MS-6332 Flex-ATX

MS6332 Ver:50C Golden Sample 7/12/2001

Micro-Star	Title MS-6332	Rev 50C
Document Number	History	
Last Revision Date: Monday, December 10, 2001	Sheet 35	of 40

Micro-Star	MS-6332	Rev 50C
Document Number	SOCKET 370 PGA-2	
Last Revision Date: Tuesday, December 11, 2001	Sheet 5	of 40

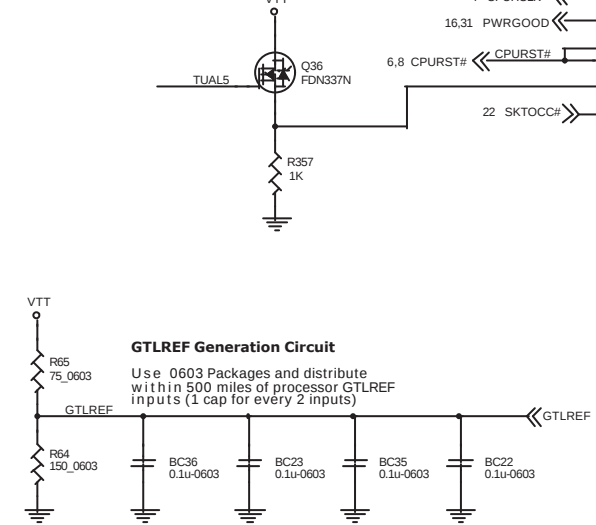
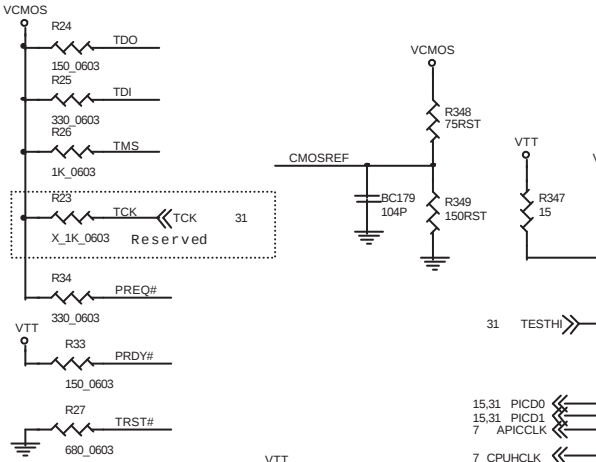
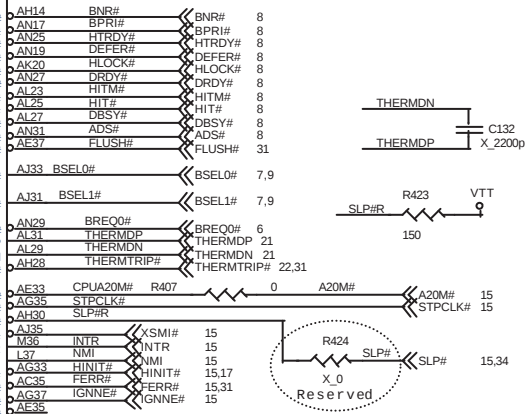
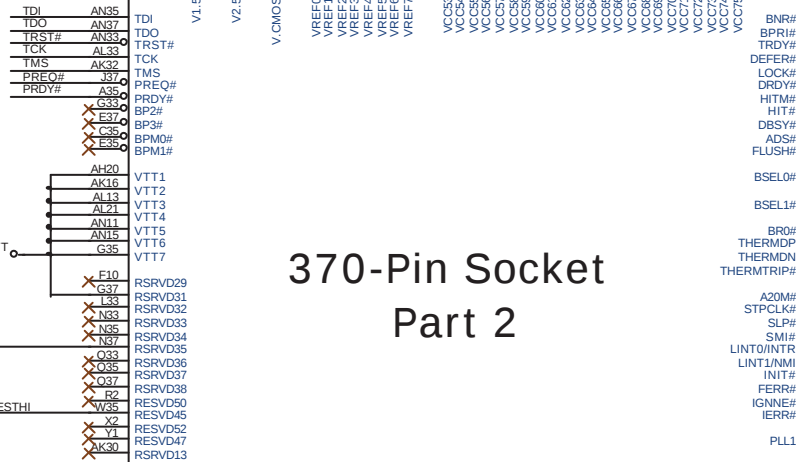
PAGE	Description	Check	Date
5	Fix AOL2 issue : The pin C37 of U2 connect to net SKTOCC#	MSI H/W	10/27/00
13,14	Spec. change : DIMM1 & DIMM2 placement exchange; DIMM1 & DIMM2 clock exchange ; DIMM1= DCLK6,2,4,5 ; DIMM2=3,7,1,0	E-mail	10/17/00
7	EMI issue (Reserved) : Add C120 , C121 with 10PF	MSI EMI	11/07/00
16,21	SM-bus issue (Reserved):Add C109,C110 with 100PF;Add R323,R324 with 4.7K;Add C112,C113 with 10PF; route ground shielding trace around SM-bus	Meeting	11/07/00
26	Fix Line-in level : Add R319,R320 with 8.2K	E-mail	11/02/00
25,26	Fix Audio frequency response: R209,R202 change from 47K to 220K & change C56-60,C76,C78,C80,C89,C90,C95 package size from 0603 to 0805	E-mail	11/02/00
27,29	Fix USB/keyboard/mouse voltage level too low issue: Add JP4 to swap VCC or 5VSB ; F1 & F2 pin1 change from 5VSTR TO 5VDUAL1	MSI H/W	10/17/00
28	Fix VRM8.4 thermal issue: 1. change EC2,EC3 package size 1500UF/16V ; 2. Chock2 use Tc6052 core with 0.8x3 wire gauge ; 3. Add R321,R322	E-mail	10/17/00 10/25/00

PAGE	Description	Check	Date
4,5	Spec change for Tualatin: Add R346,R348,R349,BC179,R347R350,Q36,R357,R352,R353,R354,R355,R356,Q34,Q35,R358 ; Del R67 & Create new net CMOSREF, TUAL5,TUALDET,VID25MV,TUAL5# ; Add R404 for Reserved	Meeting	2/08/01
7	Spec change for Tualatin: Add Q37 & Create new net VTTPWRGD12 ,VCC_CLOCK ; L16,BC33 Change net from VCC3 to VCC_CLOCK; Del L15 ; Add R359,Q38 on APICCLK signal	Meeting	2/08/01
9,16	Spec change for Tualatin: Add Q39,R360 on SM_MAA12 & TUAL5 signal ; Add 361,C136,D21,U26,R362 delay PWROK signal of ICH2 ; Del R293,R307	Meeting	2/08/01

PAGE	Description	Check	Date
5,31	Fix Intel Thermtrip# workaround :Change R23 default not stuffed ; Change R373 resistor value from 1.8K to 510; Add R410,R411,R412.	E-mail	4/12/01
29	Fix 5VDUAL have voltage output in S5 state: Change R11 from 4.7K to 10K	ECN	4/24/01

PAGE	Description	Check	Date
	Assembly issue:modify placement for Interference CHOCK1 and EC3,EC36,EC4 capacitors ; Interference EC6 and L5.	E-mail	6/22/01
05	D0-step erratum: For SLP# signal ,Add R423 with 150 ohm pull-up VTT; add R424 with 0 ohm for reserved	meeting	7/12/01
06	VRM8.5 Reserved: Add MC101for reserved and layout overlay with MC10	meeting	7/09/01
09	SM_DQM7 glitch issue: Add damper resistor R425 with 22 ohm package size 0402 on SM_DQM7 signal	meeting	7/09/01

Micro-Star	Title	MS-6332	Rev	50C
Document Number				
Clock Synthesizer				
Last Revision Date:				
Tuesday, December 11, 2001				
Sheet 7 of 40

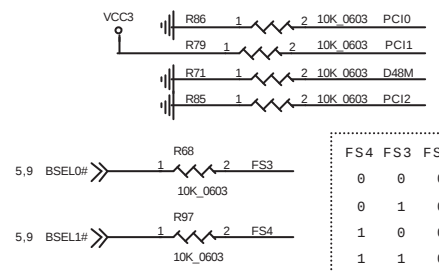
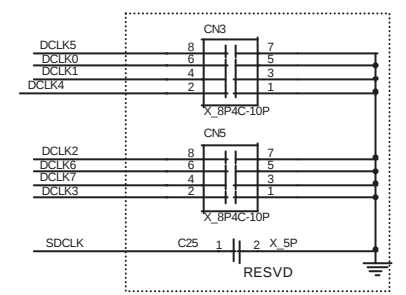
PAGE	Description	Check	Date
5	Fix ITP port layout library : The ITP port pin definition is same as J1TP1 of schematic	E-mail	10/03/00
7	Fix power on frequency setting : R68 pin1 & R97 pin1 net swap	MSI H/W	10/03/00
22	Spec change : Add JHWM1 for 2X3-pin6 pin headerfor I/F board	E-mail	10/03/00
21	Spec change : FDD1 Change from slim type to standard type	Meeting	09/26/00
26	Fix mic-phone power : Add R311 with 1.6K	E-mail	10/06/00
30	Fix system will power on when Plug in power connector : Add R312,R313,R314 R315,R316,C108,Q29 & connect signal to U25B; R17 value change from 4.7 K to 2.2K	MSI H/W	10/09/00
16	JCWD1 Password Clear GPIO pin change from GPIO5 (U15 pin M4) to GPIO4 (U15 pin N1)	E-mail	10/10/00
30	Add Cap. 104P for EMI : C107 , BC162 , BC163 , BC164 , BC165 , BC166 , BC167 , BC168	MSI EMI	10/13/00
12	Fix EMI issue : Change CP3 form Copper to L30 with 0 Ohm/0805 size resistor	MSI EMI	10/13/00

7	Fix memory issue of can not boot up : RN11 , RN14 change value from 10 Ohm to 22 Ohm	MSI H/W	10/13/00
18	Fix CNR card compatibility issue: Add R317 with 10K	MSI H/W	10/16/00

Micro-Star	Title MS-6332	Rev 50C
Document Number		
Video Connector		
Last Revision Date: Tuesday, December 11, 2001		Sheet 12 of 40

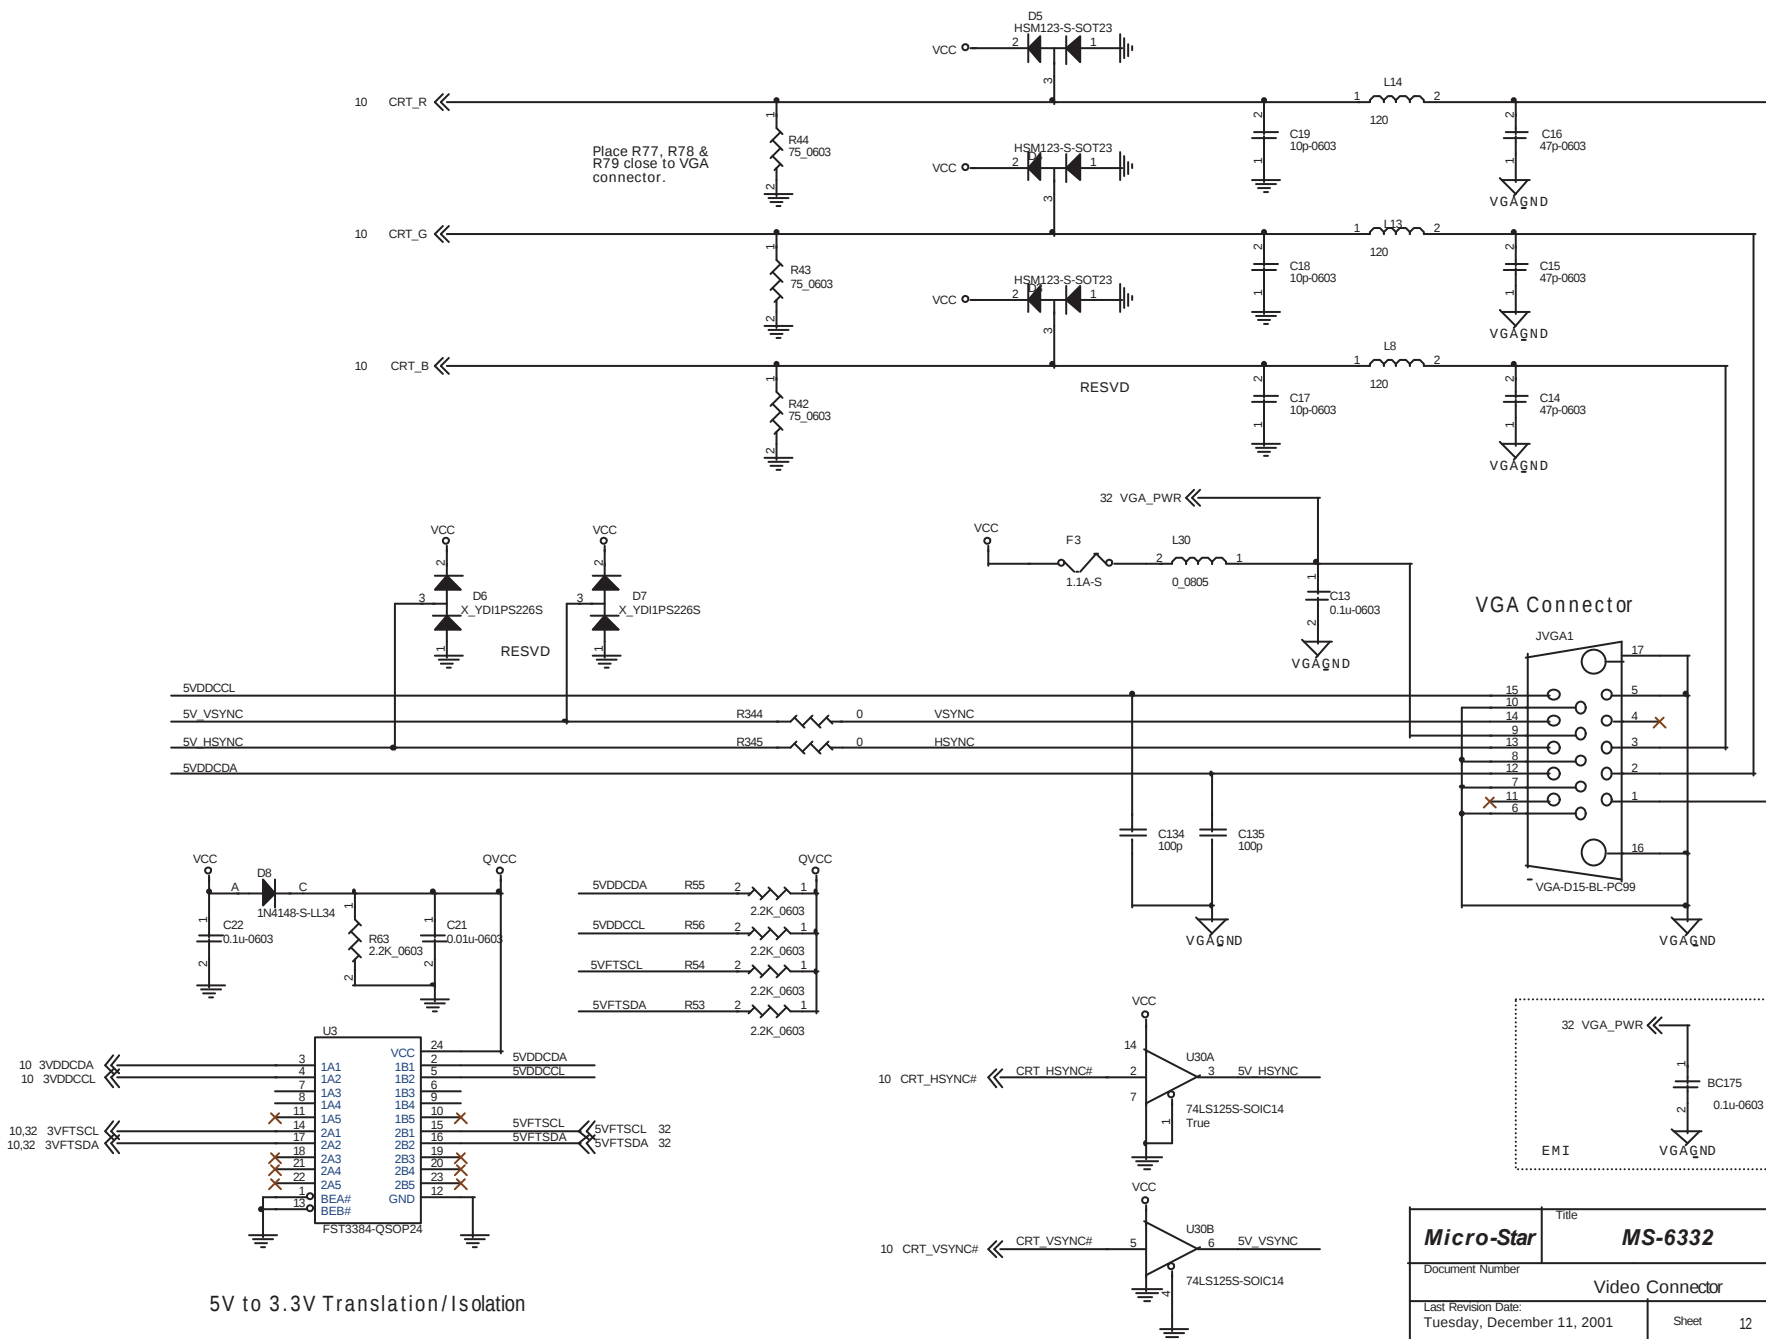
PAGE	Description	Check	Date
12	Fix 5V_VSYNC and 5V_HSYNC signal quality issue: Add series resistor R344 , R345 on 5V_VSYNC & 5V_HSYNC signal .Also add C134 , C135 on 5VDDCCL & 5VDDCDA signal and del CN2.	Meeting	2/01/01

PAGE	Description	Check	Date
12	Fix VGA noise issue: Add U30 Connect net on U30 pin2,3,5,6 & U30 pin1,4,7 connect to GND , pin14 to VCC &; Disconnect U3 pin7,8,6,9	E-mail	4/11/01
6	VRM8.5 Spec. Fine tune : Del MC4. Move MC15 close to MC20 . MC5,MC9,MC11 package size change to 1206. Every Pad of 1206 size Cap. have to two via on GND and VCCP . These two via of pad must be have fat copper.	Meeting	3/20/01
28	Improve interference problem between heatsink and Chock2. Update Chock2 Layout library with CHK6852A. Fine tune Q7,Q8,Q40,Q45 position for more thermal copper space.Q7,Q45 change to IPD07N03 Rds=7.5mOhm	E-mail	3/26/01
33	Rename SYSFAN1 to PWRFAN1; Add BC190 and 3 pin fan connector SYSFAN1. The SYSFAN1 layout library is same as CPUFAN1 Change CPUFAN1 , SYSFAN1 and PWRFAN1 position	E-mail E-mail	3/15/01 4/10/01
28	VRM8.5 OCP point:R16 keep 1.62K,C137 from 1u change to 4.7U,R368 from 15 change 47,R369 from 36 change to 47 ohm,R366 from 20K change to 33K	H/W DQA2	3/20/01

Micro-Star	Title MS-6332	Rev 50C
Document Number LPC Super I/O		
Last Revision Date: Tuesday, December 11, 2001		Sheet 21 of 40

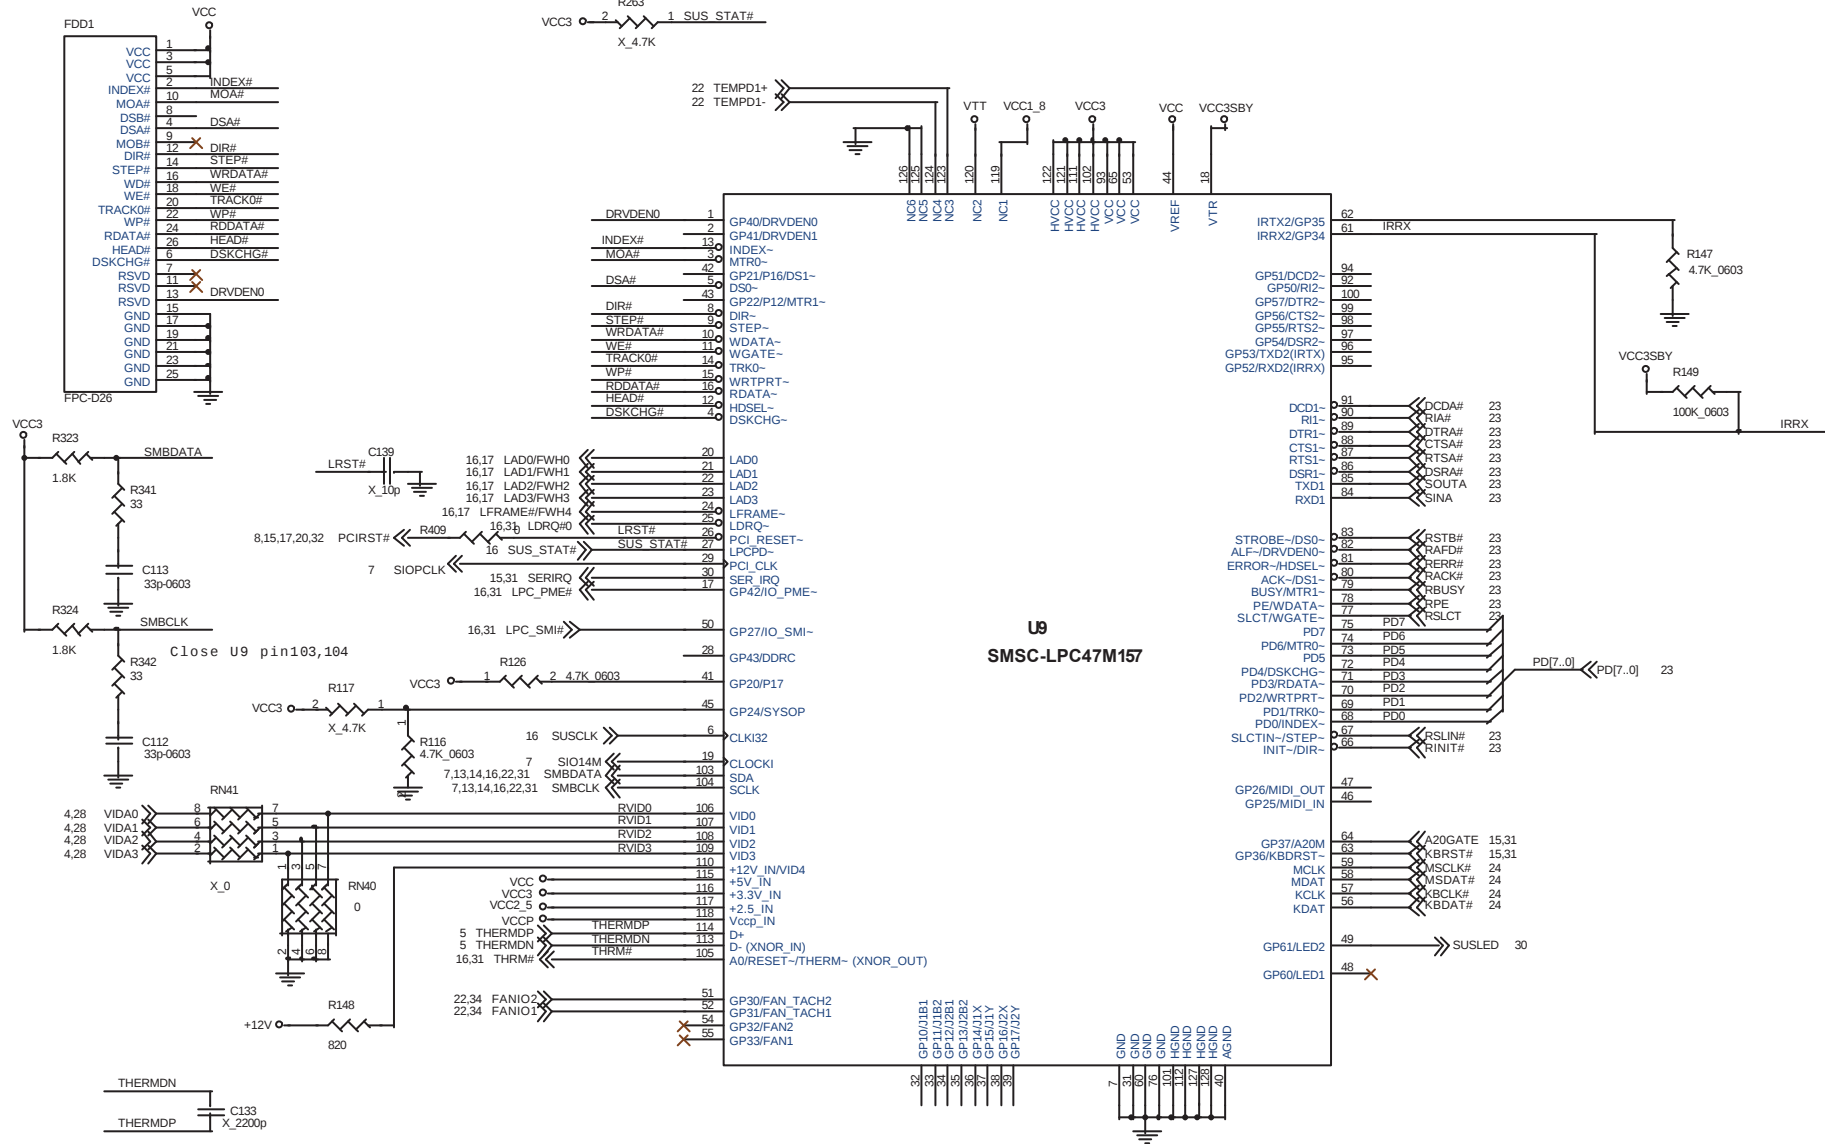
30	Fix SUSLED issue: R281 pin1 net change from 5VSB to GND	E-mail	10/25/00
21	Fix Fdd & LPC47M157 data sheet incorrect issue : stuff R138,R151 with 1K ; U9 pin125,126 connect to GND	E-mail	10/25/00
10	Fix DVI issue : Don't stuff R101 , R88 from 1K change to 4.7K	MSI H/W	10/25/00

07,19	Spec change for PCI: Del R242,R249,PCI1& disconnect RN12 pin1,2 & U5 pin15	Meeting	2/19/01
21	Spec change for FDD1: Change FDD1 from standard type connector to slim tpye connector ; Add r409,c139 Reserved for meet LPC timing spec of ICH2.	Meeting	2/19/01
22,34	Spec change for FAN speed control of I/F card on board:Add Q46,Q47,Q48,Q49,Q50,R385,R384,R388,R391,R389,U29,BC184,R387,R390,EC40,R386,R393,R394,R398,R392,R395,R396,R397 & P8 for CPU FAN connector & P9 for system FAN connector & P3 for CD-IN connector ; Del JHWM1 connector	Meeting	2/19/01
7,15	Spec change for PC2001: Add R403 for IOAPICCLK of ICH2 & connect PICD0,PICD1 to ICH2 ; Add R408 series be connected between the pin AE33 of CPU and A20M# ; & Add R407,R406 for PC2001Reserved	PC2001	2/27/01
30	EMI request: Add BC186, BC187	EMI	03/1/01

Micro-Star	Title	MS-6332	Rev	50C
	Document Number	Hardware Monitor		
Last Revision Date:		Wednesday, December 12, 2001	Sheet	34 of 40

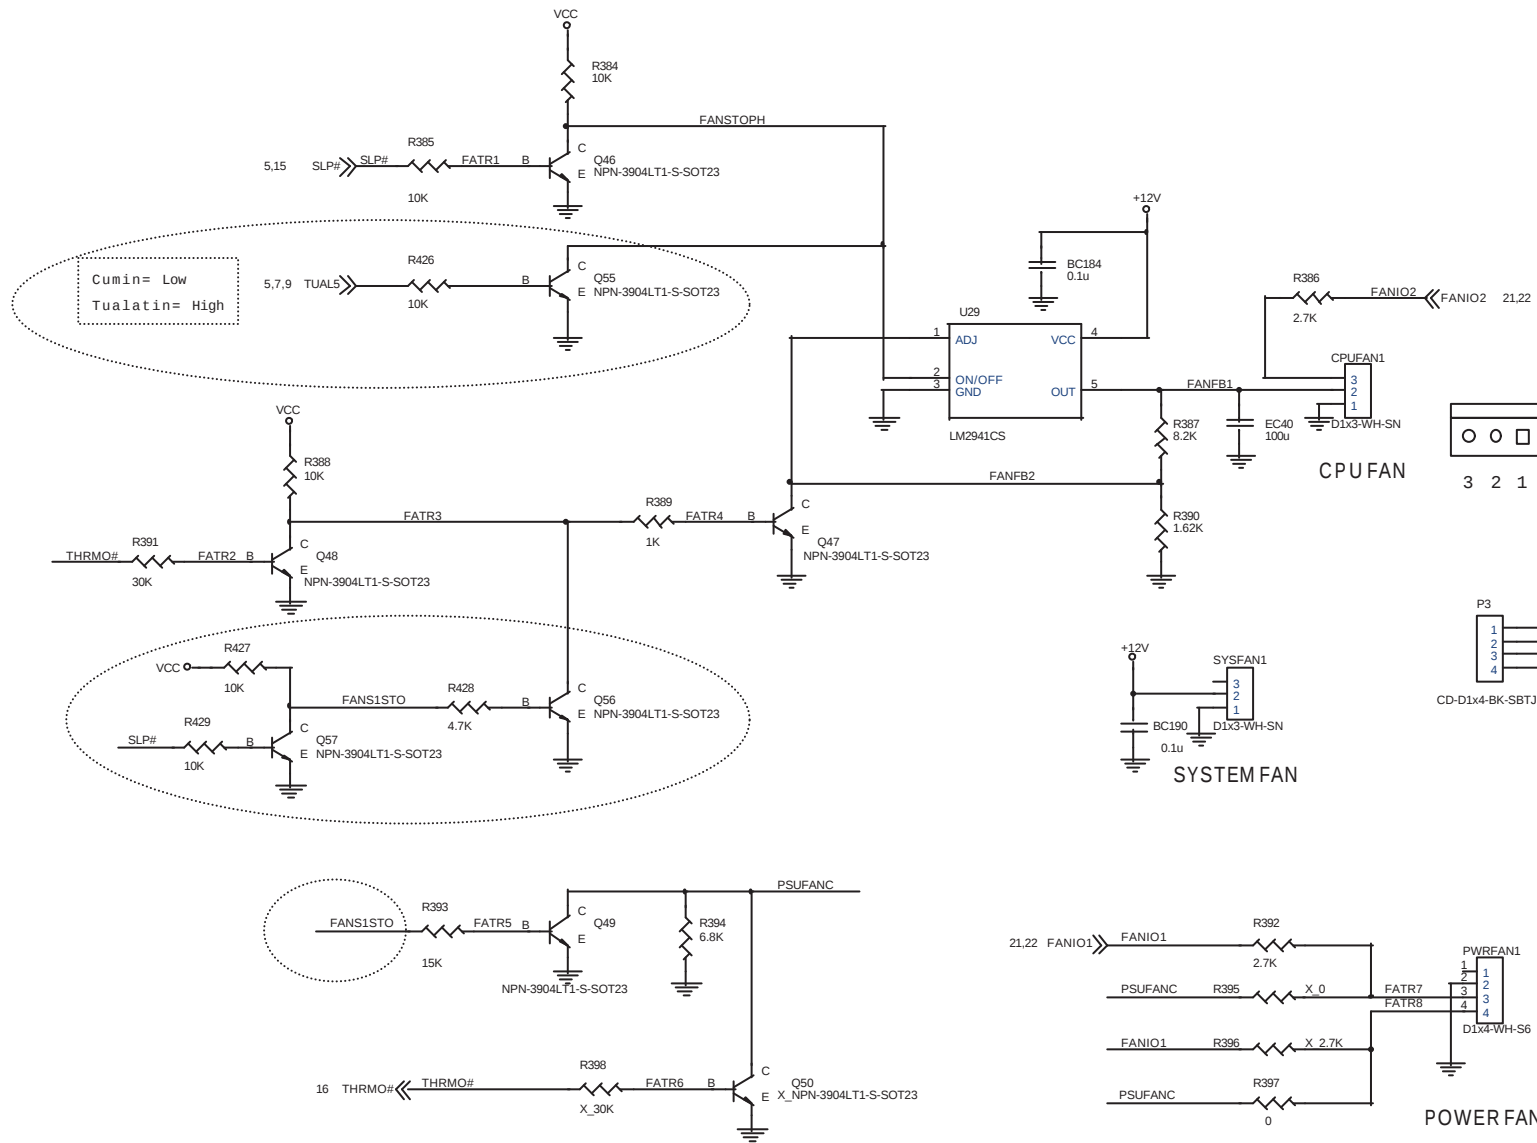
16	Improve RTCRST# to meet RC time delay Spec of ICH2:Change R310 from 8.2K to 15K ; Change C106 from 0.01u 0603 t0 1u 0805 X7R	MSI check list	3/23/01
	Modify some silk print on the original CNR area to put bar code label . Check Add silk print of the CPU	E-mail	3/23/01
34	Change R387 resistor value from 6.19K to 8.2K	E-mail	4/11/01
